City of Foster City

Subject: Window Replacements to Meet Building Code Egress Requirements in Bay Vista (AR-04-219) (AR-07-141)

CITY OF FOSTER CITY
COMMUNITY DEVELOPMENT DIRECTOR'S ACTION
NOTICE OF DECISION

BAY VISTA HOMEOWNERS' ASSOCIATION
Prototypical Design Guidelines for Replacement Windows and Sliding Glass Doors

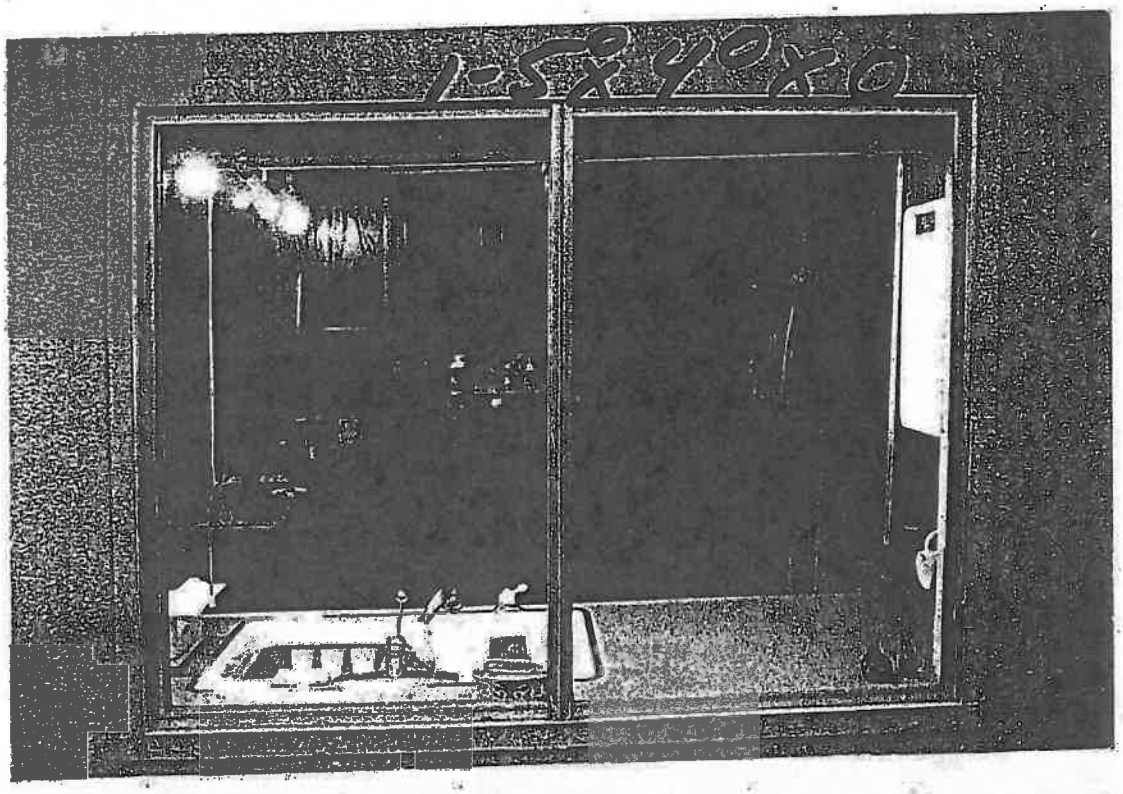
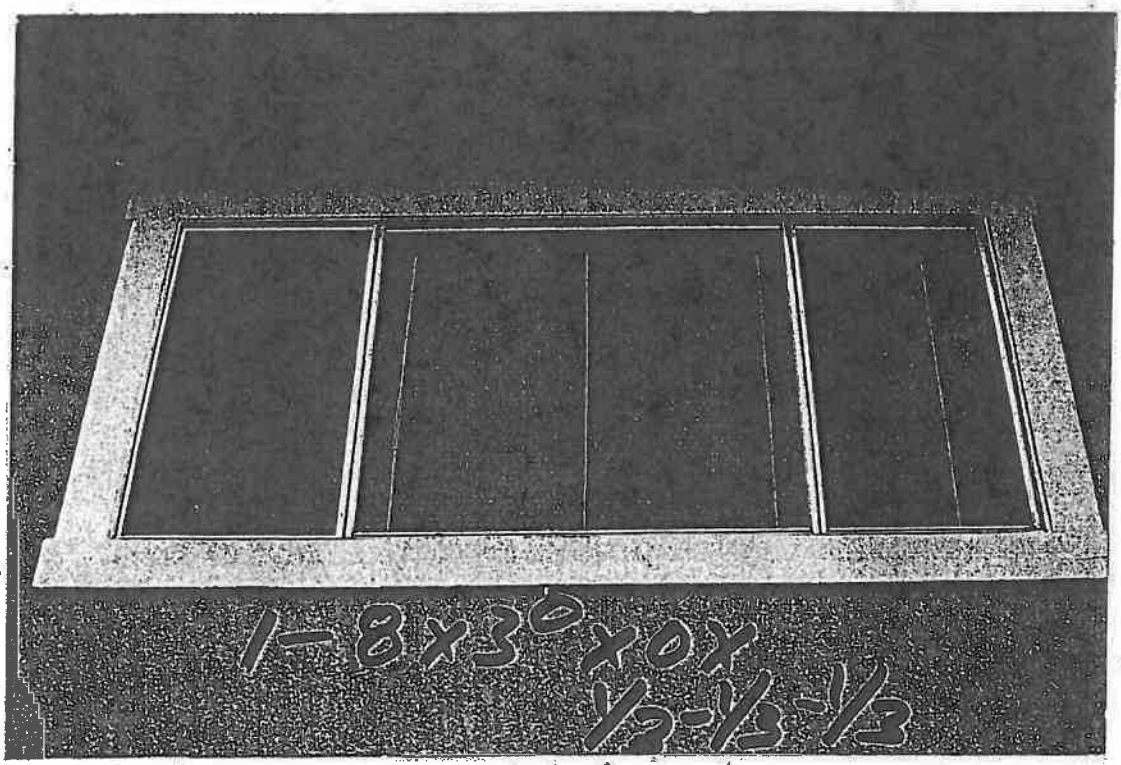
→ increase width to 24"

UPSTAIRS BEDROOM DONT MEET EGRESS Single casment

1. The pair of bedroom slider windows that are currently each 3' wide by 4' tall with wood trim between them will be changed to be two casement windows so that they can meet the minimum opening width requirement. The wood trim between the two windows will remain so that the only change will be the elimination of the vertical dividers in the current slider windows.

2. The three-piece upstairs 8' wide by 3' tall bedroom window that is currently a fixed center with two sliding sides will have the size of the sliders increased to 24" to meet the minimum opening width requirement.
